BMP NUMBER: **MC011**

DRAINAGE, SEDIMENT AND EROSION CONTROL PLAN
DIGGES BROTHERS OFFICE/WAREHOUSES

CODE COMPLIANCE PLAN REVIEW COMMENTS
DIGGES BROTHERS OFFICE/WAREHOUSES
PLAN NO. SP-62-88 DEC
February 23, 1989

EROSION CONTROL REVIEW COMMENTS
DIGGES BROTHERS OFFICE/WAREHOUSE DEC
SITE PLAN NO. SP-62-88

Designed	Drawn
SOW	RMS
Scale	Date
NOTED	MAY, 1988
Project No.	
7080	
Drawing No.	
3

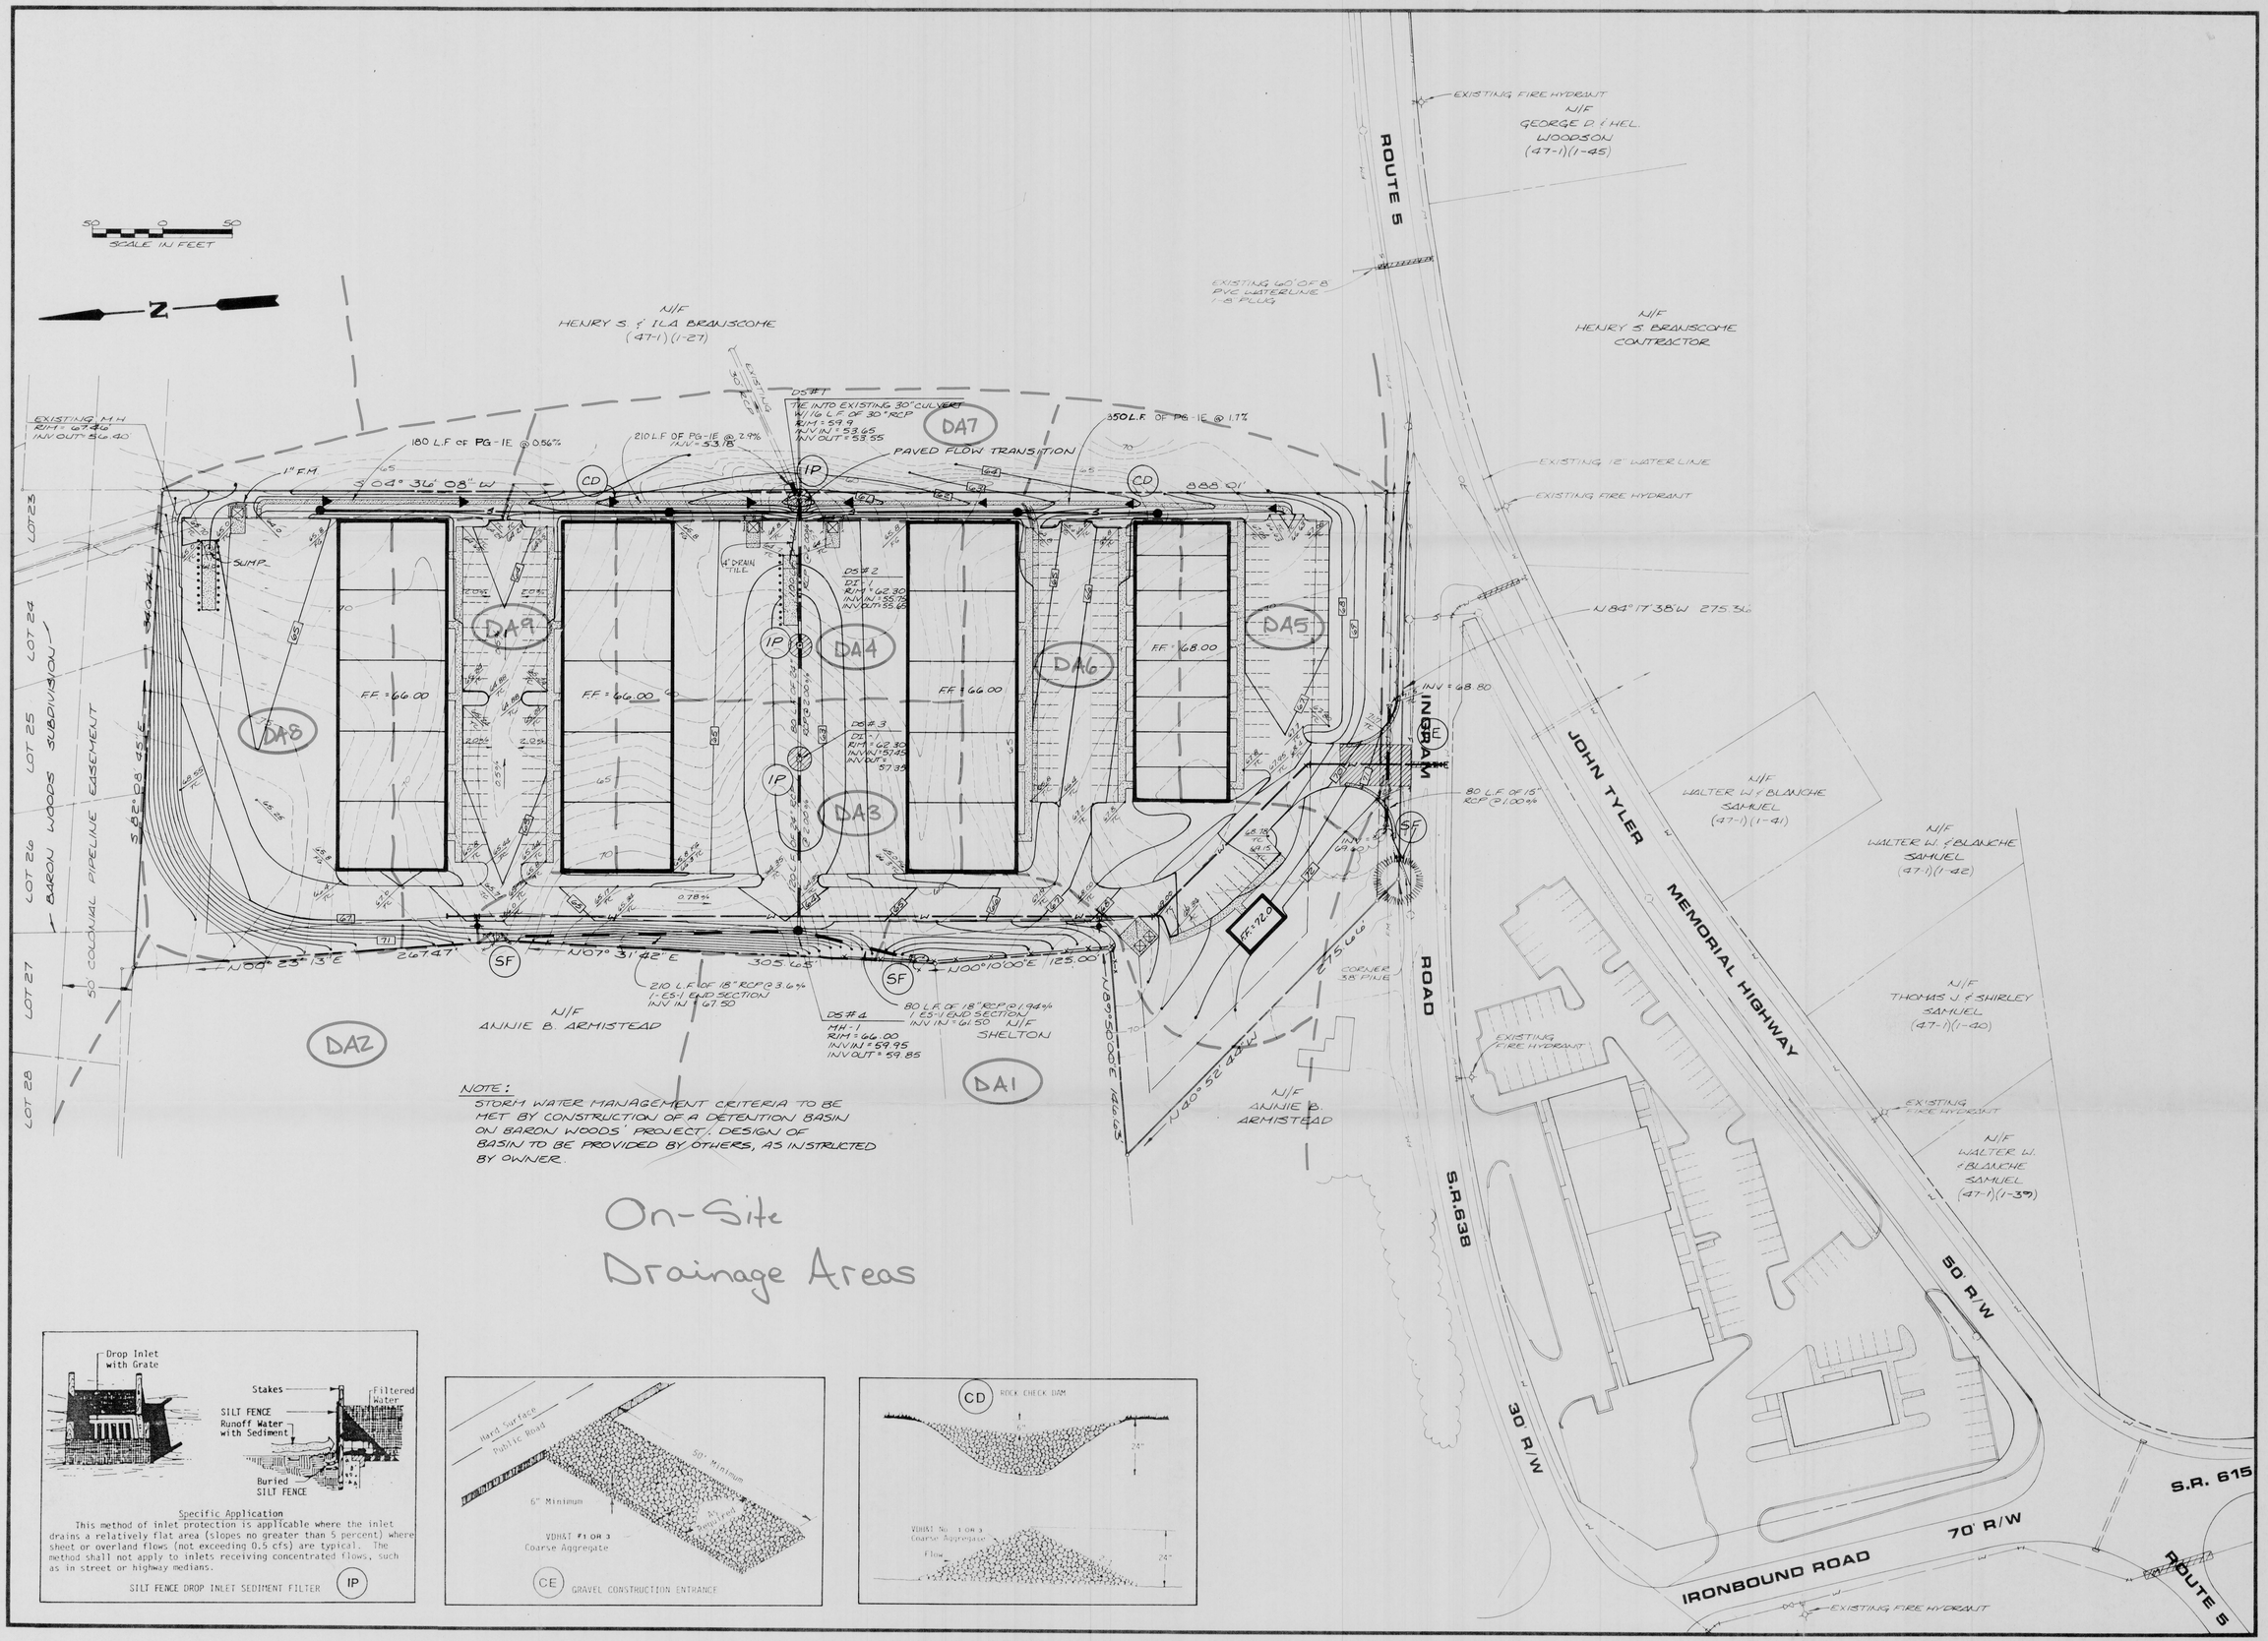
2. Remove the note on Sheet 3 that states that Stormwater Management is to be met by construction of a detention basin on Baron Woods. This is incorrect. Provide Stormwater Management on the site through a combination of parking lot storage and detention storage in the area adjacent to the existing 30-inch pipe.

NOTE:
STORM WATER MANAGEMENT CRITERIA TO BE MET BY CONSTRUCTION OF A DETENTION BASIN ON BARON WOODS' PROJECT. DESIGN OF BASIN TO BE PROVIDED BY OTHERS, AS INSTRUCTED BY OWNER.
